Our Ref: J27035

10 February 2011

ESKOM ENVIRONMENTAL IMPACT ASSESSMENT (EIA:12/12/20/944) FOR A PROPOSED NUCLEAR POWER STATION AND ASSOCIATED INFRASTRUCTURE: COMMENTS ON THE DRAFT ENVIRONMENTAL IMPACT ASSESSMENT REPORT

Figure 1: Comparison of life-cycle greenhouse gas emissions of different electricity generation systems (from Dones et al. 2003)

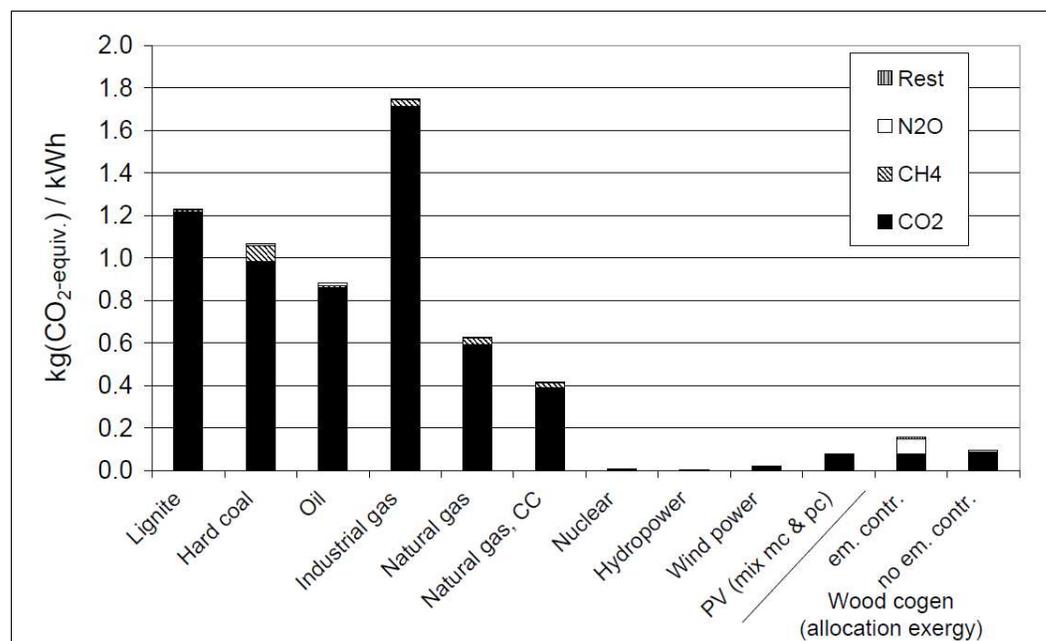
It is also clear that this process is not looking at full costs, or life cycle costs, a fatal flaw. We request that each energy/ electricity option be studied with a full life cycle analysis in mind, from extraction to final decommissioning and waste handling for all options. This is a specific requirement from the DEA documentation in our hands.

Your comments are noted. This application for environmental authorisation relates specifically to the impacts of a Nuclear Power Station on three specific sites: Duynefontein, Bantamsklip and Thyspunt. It is not the intention of this EIA, neither was it required by the DEA approval of the Plan of Study for EIA, to perform a full life cycle analysis. Reference is made to life cycle impacts of different generation options in Section 4.2.2 of the Draft EIR and revised Draft EIR. An analysis of the life cycle impacts of nuclear power generation vs. other generation technologies indicates that nuclear power emits less than 11 grams of carbon equivalent per kilowatt-hour (g_{CO_2-eq}/kWh) (Dones et al. 2003¹). This is the same order of magnitude as wind and solar power. This is also two orders of magnitude below (i.e. one hundredth of) the average for coal, oil, and natural gas (Figure 1). Apart from these benefits, nuclear power generation does not emit sulfur dioxides (SO_x), nitrous oxides (NO_x) and requires much less water than coal-fired power stations, as the proposal for Nuclear-1 is to make use of sea water for cooling. This is a particularly important factor in a water-stressed country like South Africa.
